STATE OF VERMONT AGENCY OF TRANSPORTATION

PROPOSED IMPROVEMENT TOWN OF PERU COUNTY OF BENNINGTON VT ROUTE 11 (MINOR ARTERIAL)

Record Plans

DIRECTOR OF PROJECT DELIVERY	APPROVED DATE 12/31/2014
PROJECT MANAGER : KEN UPMAL, P.E.	
PROJECT NAME : PERU	
PROJECT NUMBER : STP SCR(4)	
SHEET 1 OF 45 SHEETS

THIS SHEET REPLACES PRECEDING SHEET

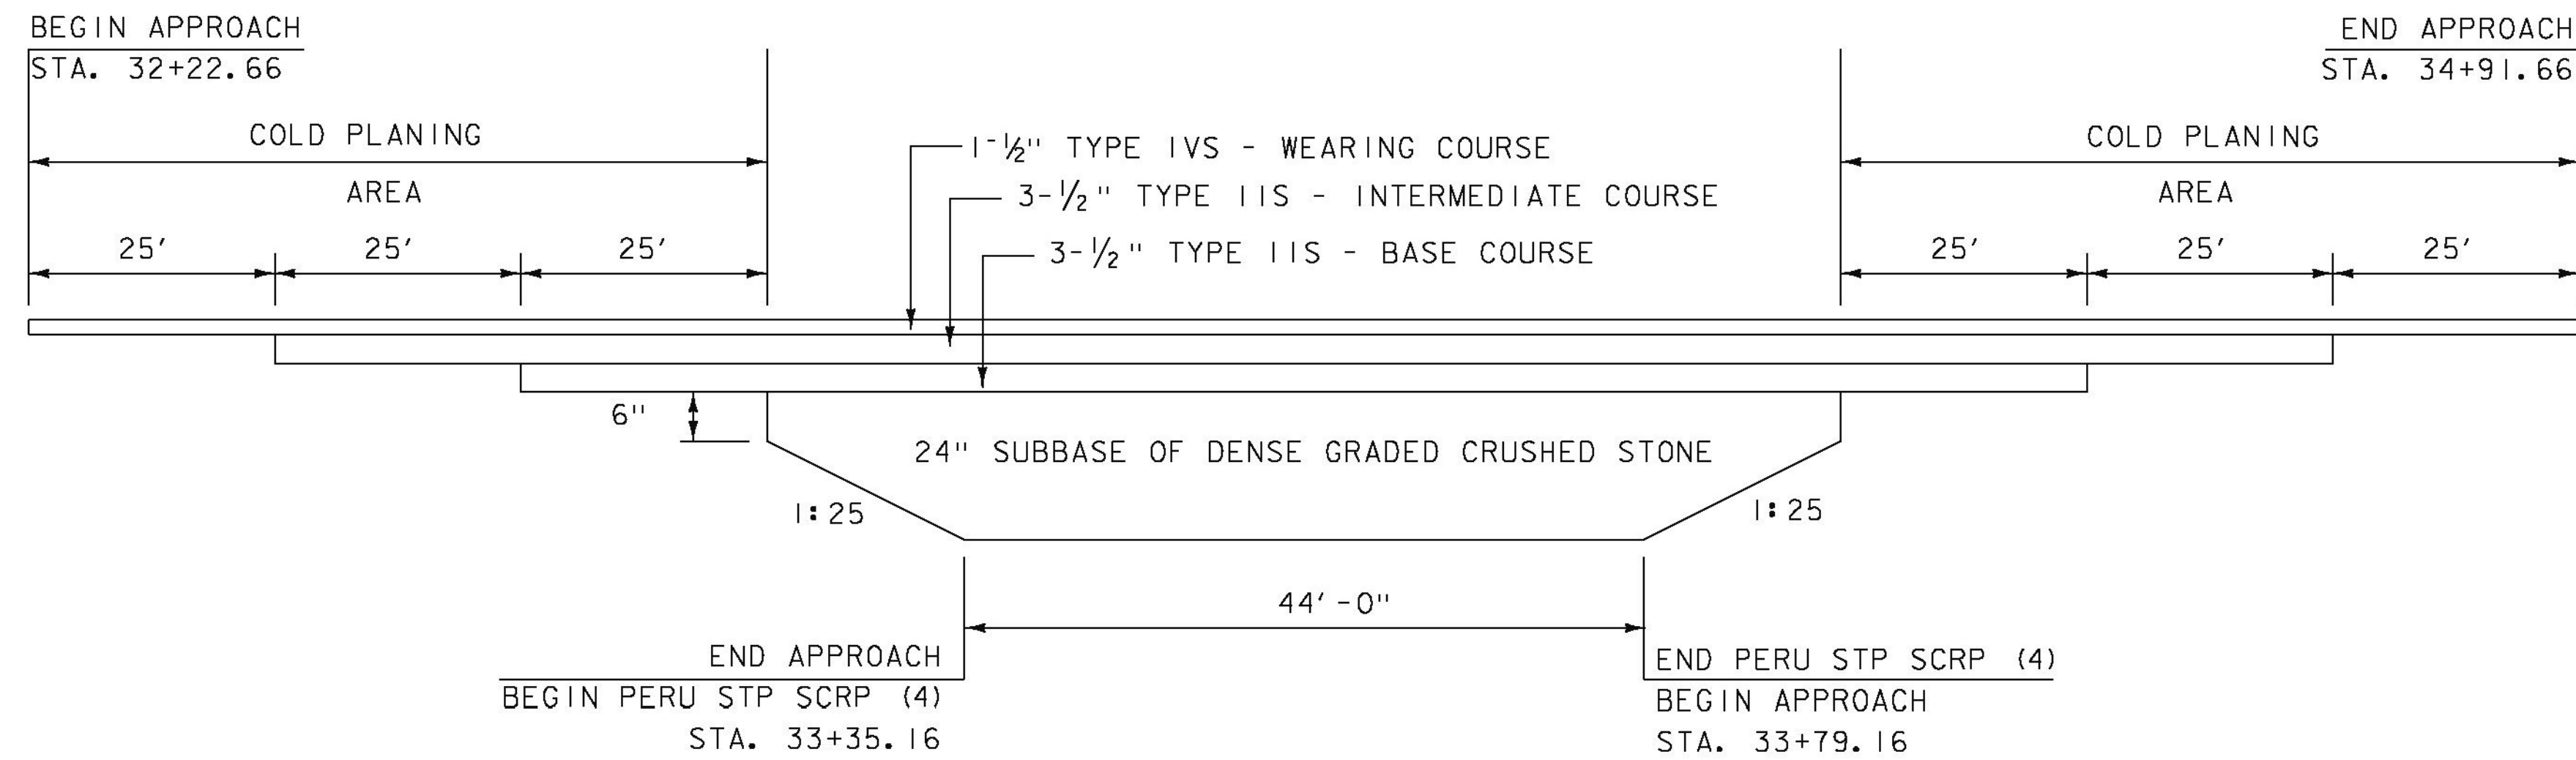
REVISION	BY	DATE
△ SECOND ASTERISK WAS ADDED TO NOTE AND ELEVATION CALLOUT	MAB	2/10/2015
△ PROFILE UPDATED TO REFLECT ADDITION OF BAFFLE W/ WEIR.	MAB	6/8/2015

△ ** PIPE ENTERS STRUCTURE OFF CENTER, PROJECTED ENTRY LOCATION SHOWN
